ALABAMA PECAN SUBDIVISION, PHASE 1

APPLICATION NUMBER 3 DATE March 15, 2018

APPLICANT Alabama Pecan Subdivision, Phase I

REQUEST Subdivision

DETAIL SITE PLAN

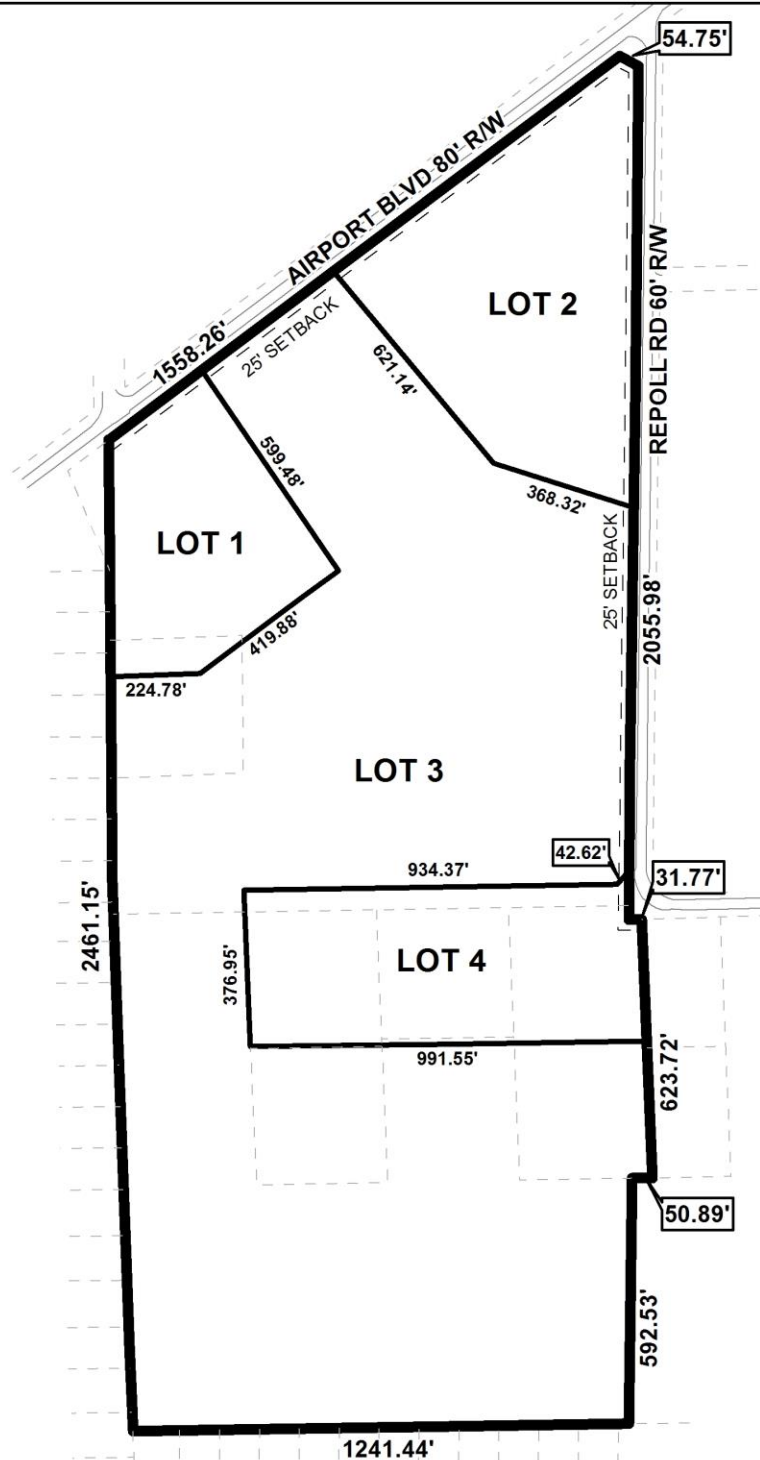
The site fronts Airport Boulevard and Repoll Road. Airport Boulevard is a proposed major street with a planned 100' right-of-way, as illustrated on the Major Street Plan. However, the plat indicates the right-of-way width of Airport Boulevard as 80'. Therefore dedication of any necessary right-of-way to provide 50' from centerline of Airport Boulevard will be required. The plat depicts Repoll Road as having a 60' right-of-way; therefore no dedication will be required.

The site is bounded along the west side by a proposed major street, a new connection linking Eliza Jordan Road to Johnson Road West. The right-of-way is proposed to be 100 feet, thus the plat should be revised to reflect dedication of the right-of-way.

Based on the preceding, the application is recommended for Holdover to April 19th with a revised plat reflecting the proposed Eliza Jordan Road major street extension to be submitted by Wednesday, March 28th.
